**RE:** 131 Danbury Road, Wilton CT – 131 Danbury Wilton Dev AMS, LLC

This letter is written in response to the review of the submission by Redniss & Mead dated November 17, 2023 and response letter/submission dated January 8, 2024 for the proposed development on 131 Danbury Road. Based on the review of the above-mentioned submission at this time, the items listed below were part of our review letter dated January 5, 2024 with updated comments in bold:

**RE: Downstream Sewer Capacity Analysis**  
**131 Danbury Road**  
**Wilton, Connecticut**

**SITE PLAN - UTILITIES**

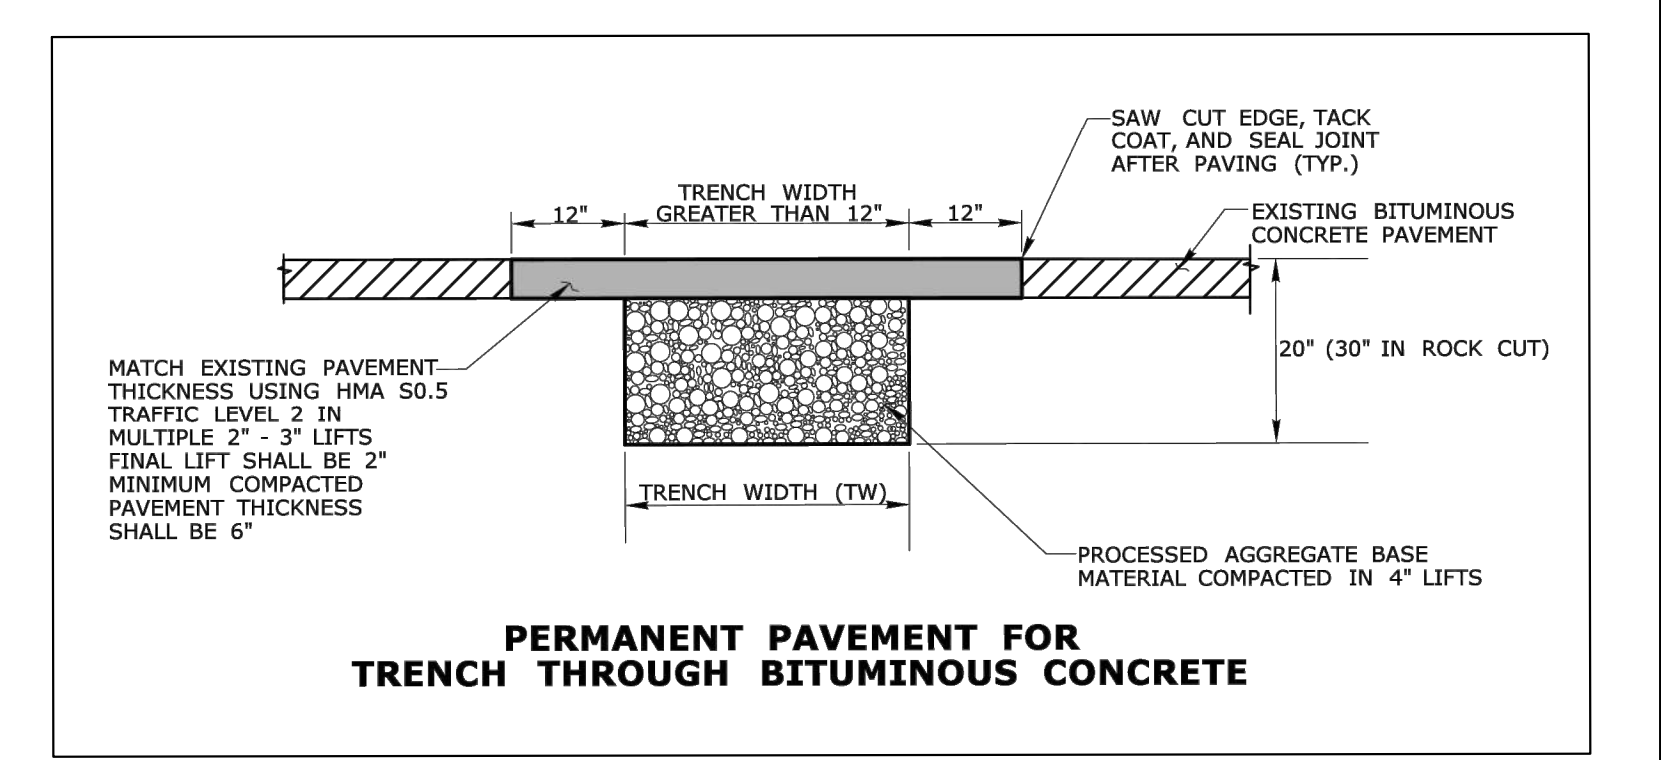
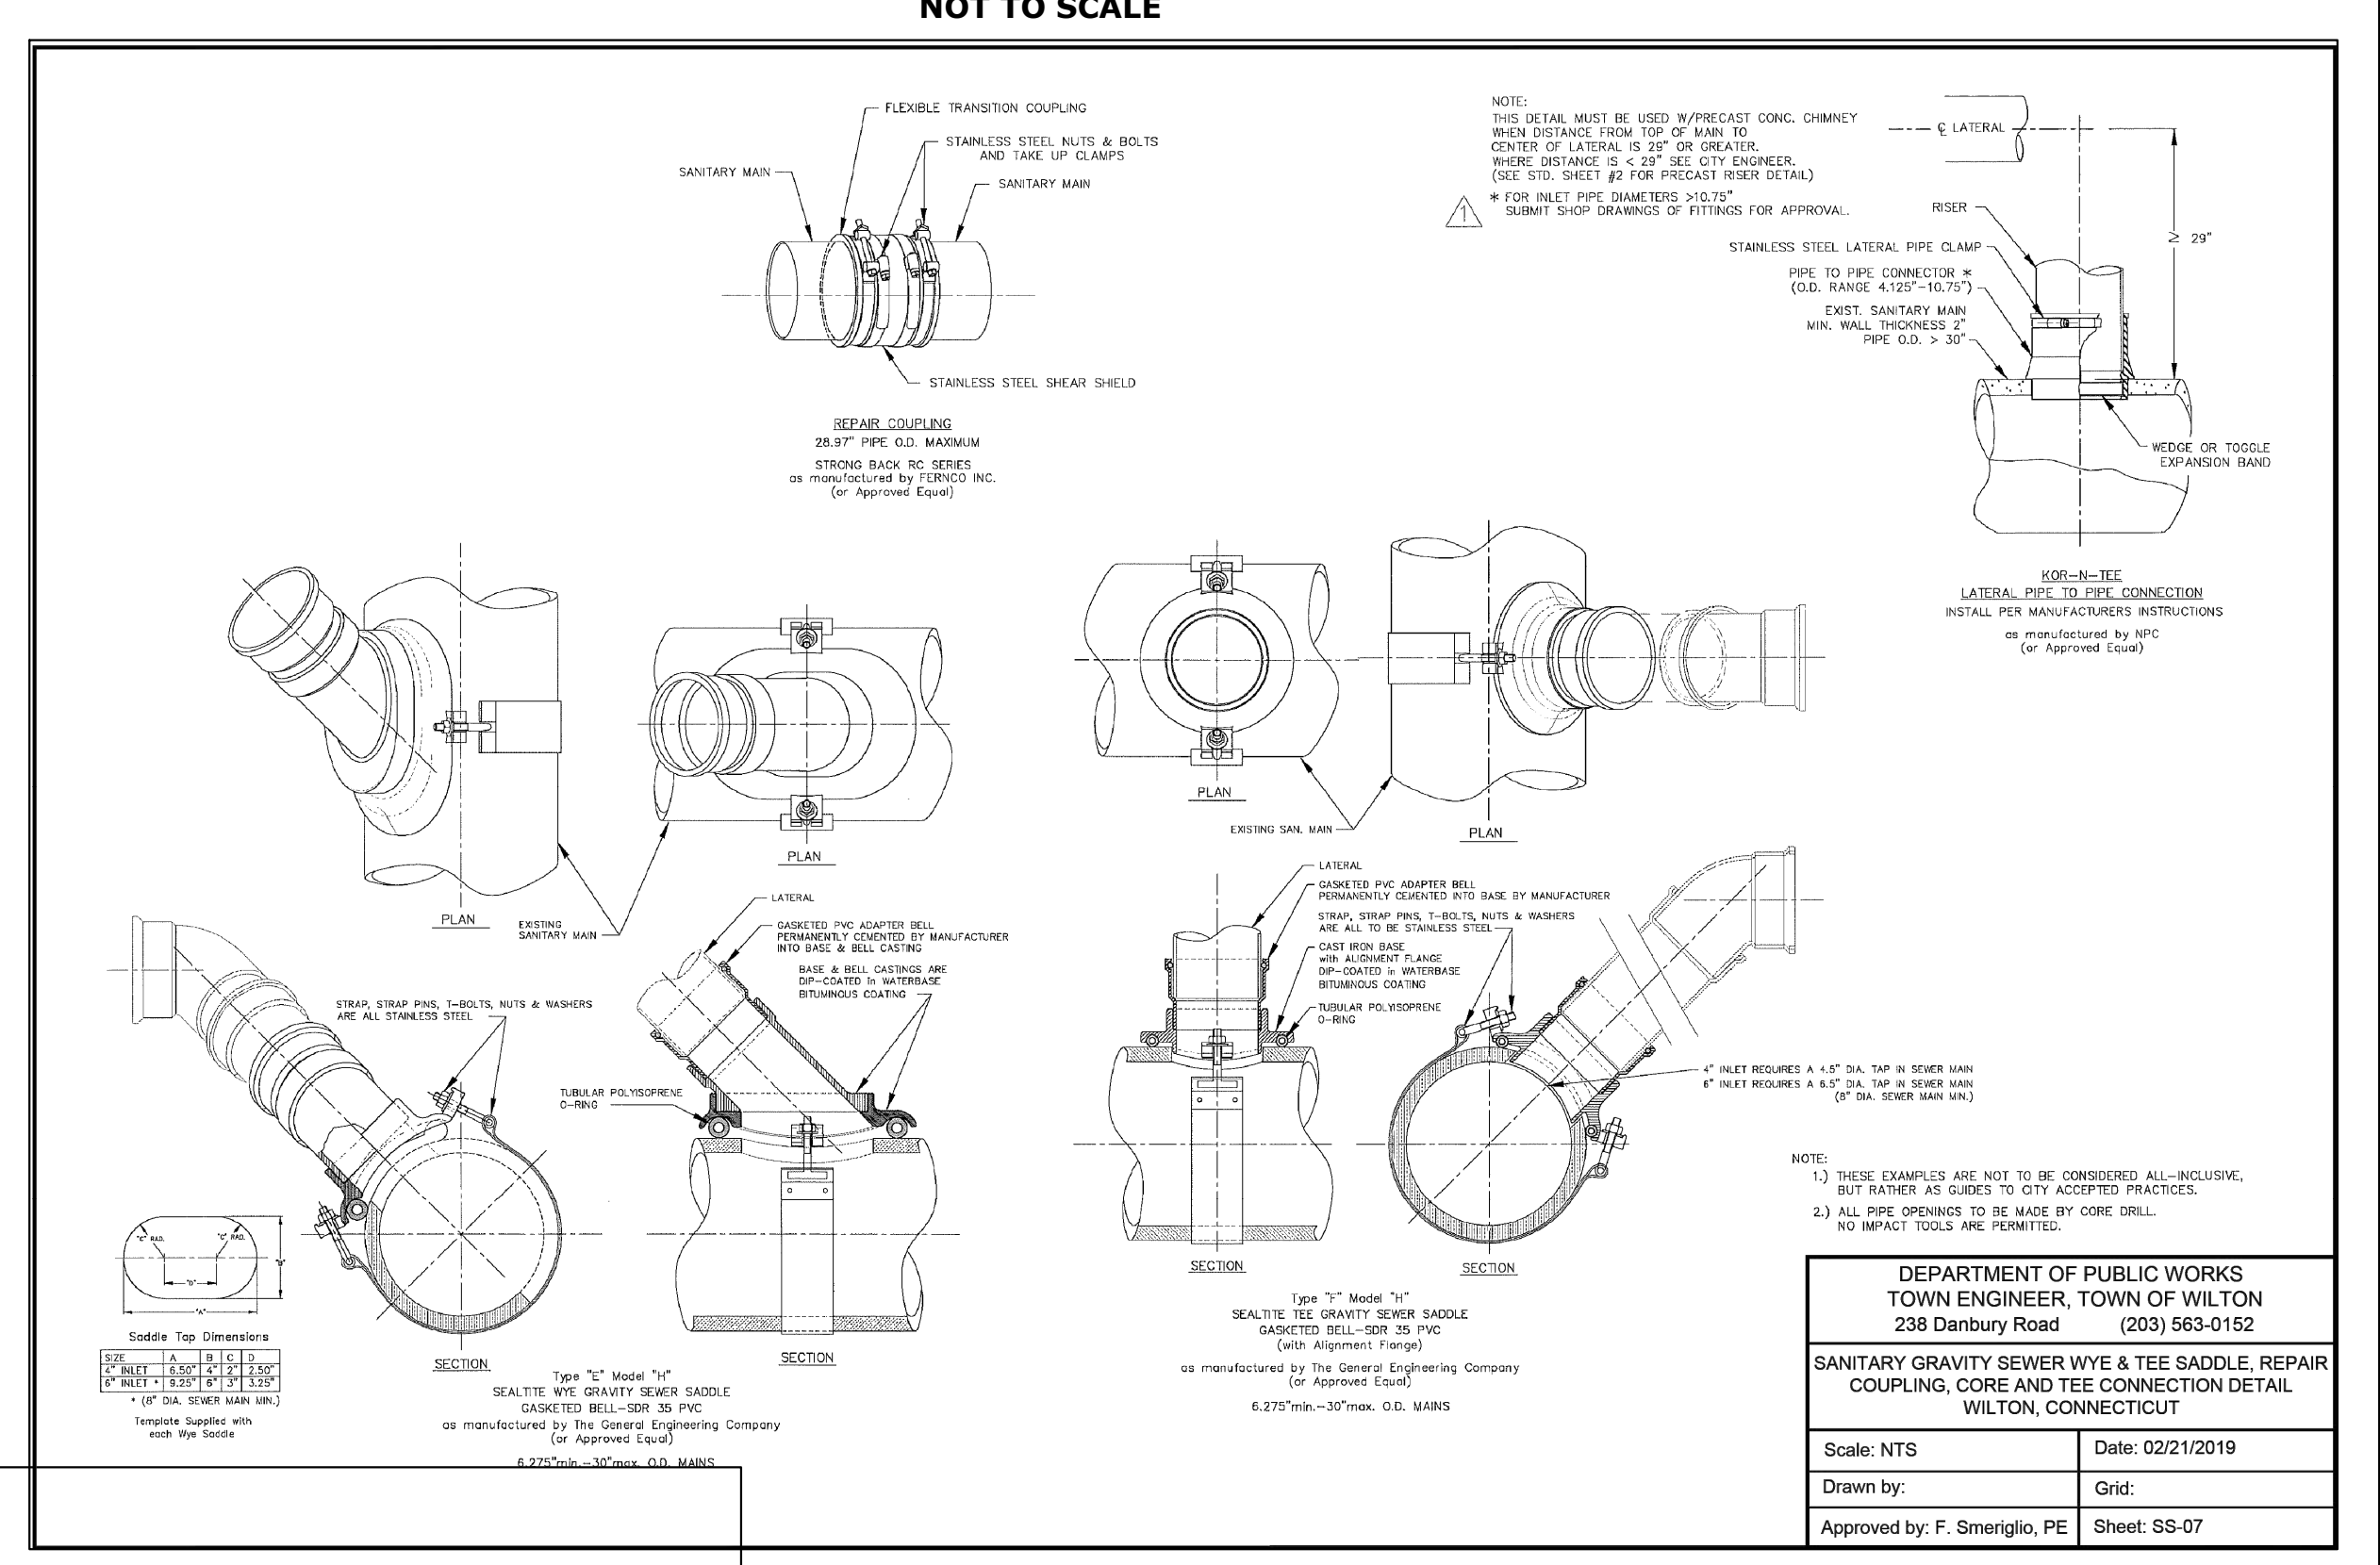
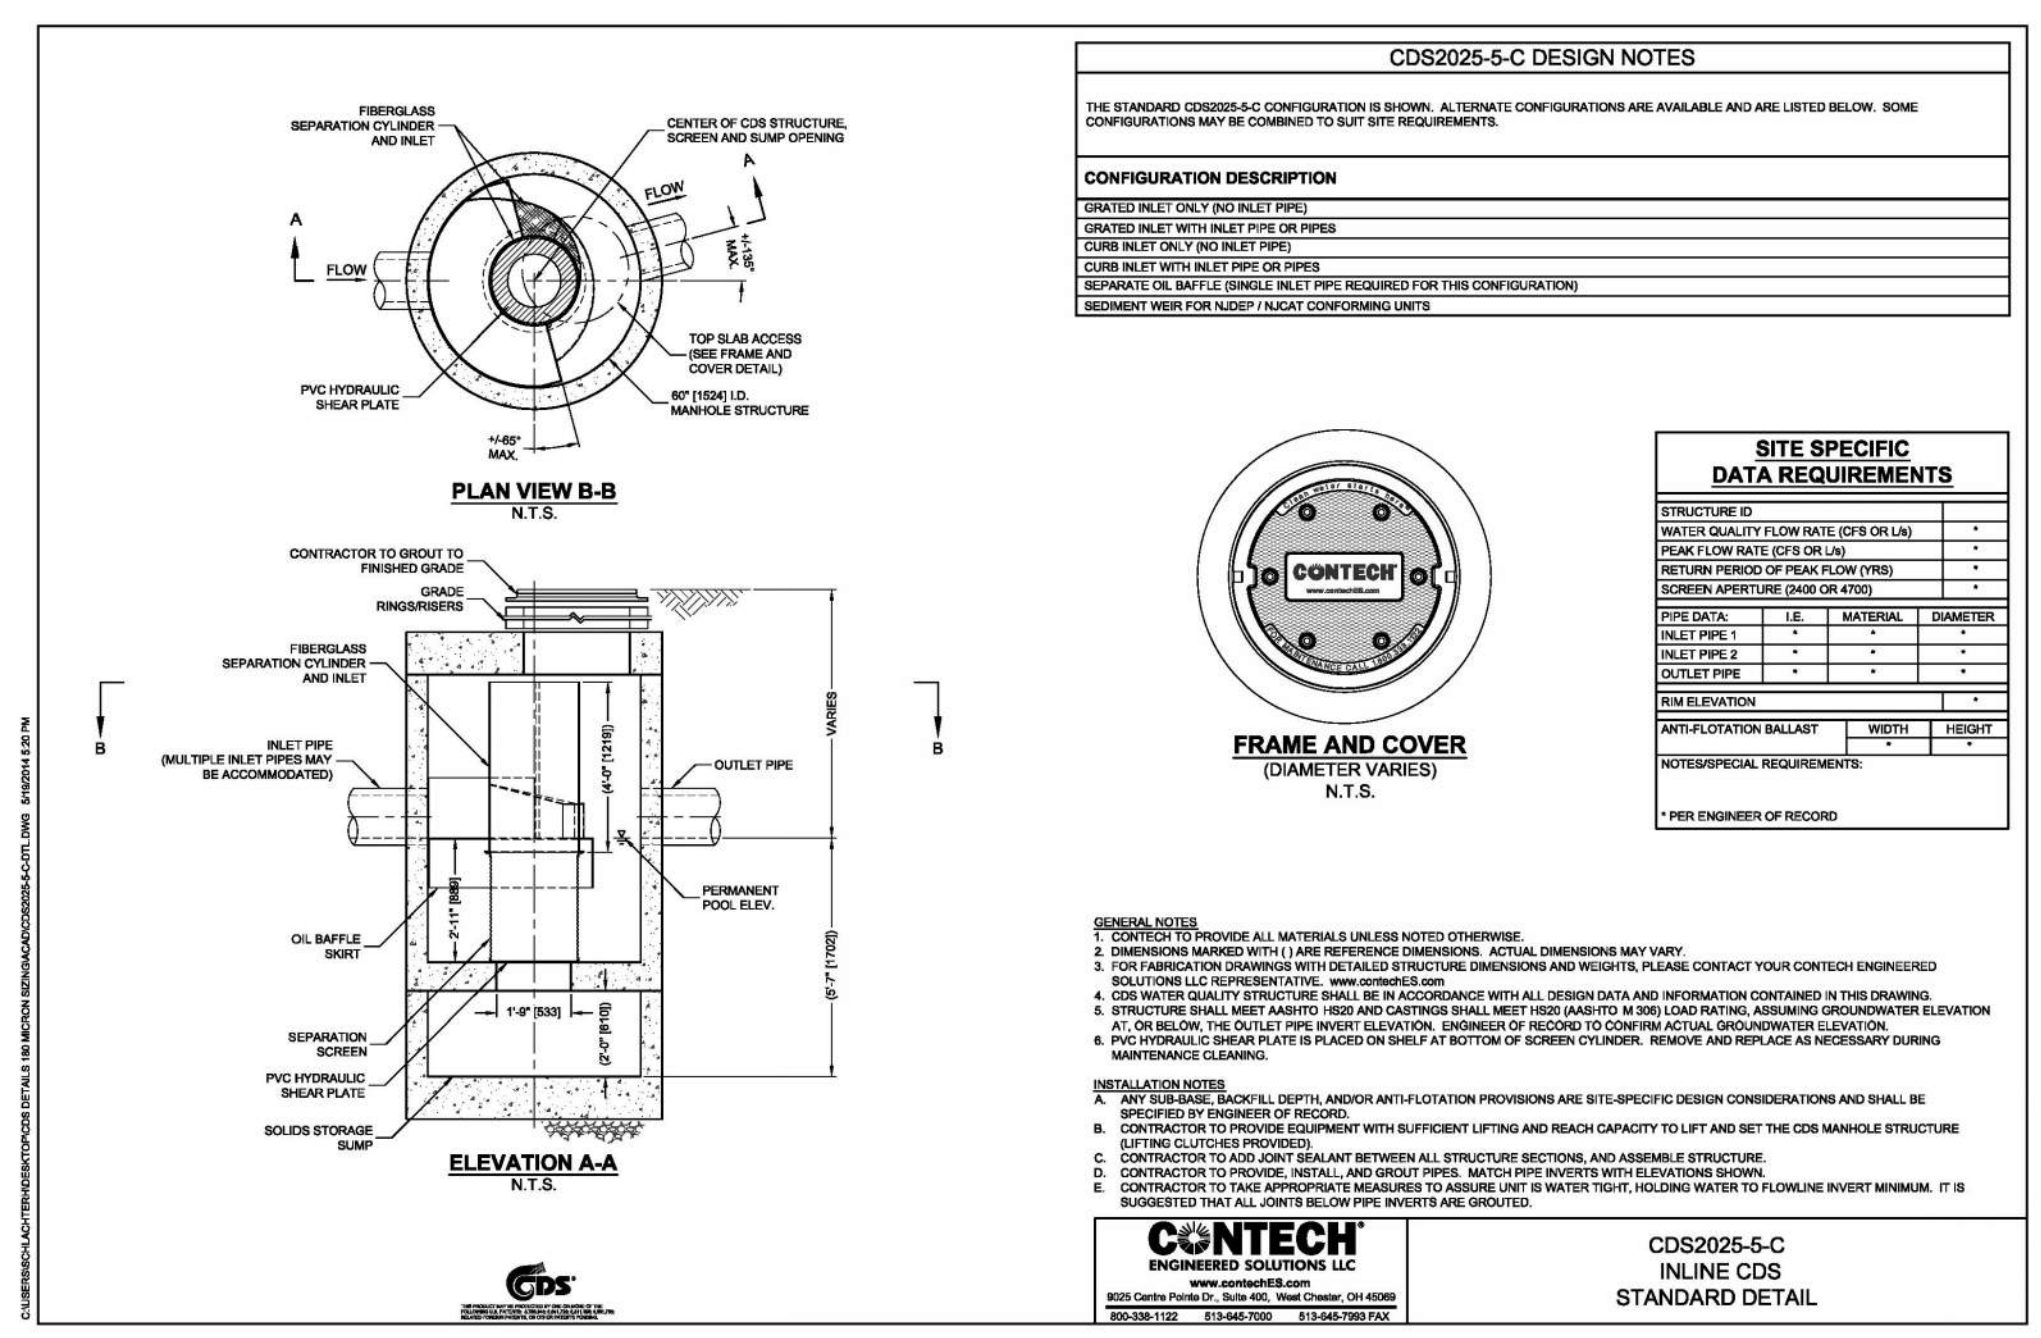
- 5) Engineer to evaluate the use of an 8" sewer line. The proposed sewer lateral shall be connected to a new manhole along the existing sewer main within Route 7. Modify details.

- 4) Design Engineer shall address Norwalk WPCA's review as per email dated 11/28/23.
- 5) Engineer to evaluate the use of an 8" sewer line. The proposed sewer lateral shall be connected to a new manhole along the existing sewer main within Route 7. Modify details.

**Addressed – final details/plans shall be reviewed prior to signoff of building permit**

4. Calculations were provided indicating that a six-inch pipe has sufficient capacity to accommodate peak flows from the proposed building. However, given the comment from the Norwalk WPCA, the lateral size has been changed to an eight-inch diameter as indicated on the updated plan dated January 5, 2024. Also indicated on the updated plan is a manhole at the connection point to the sewer main in the street.
5. See item 4 above.
6. No drains in the parking area below the building are proposed or required.
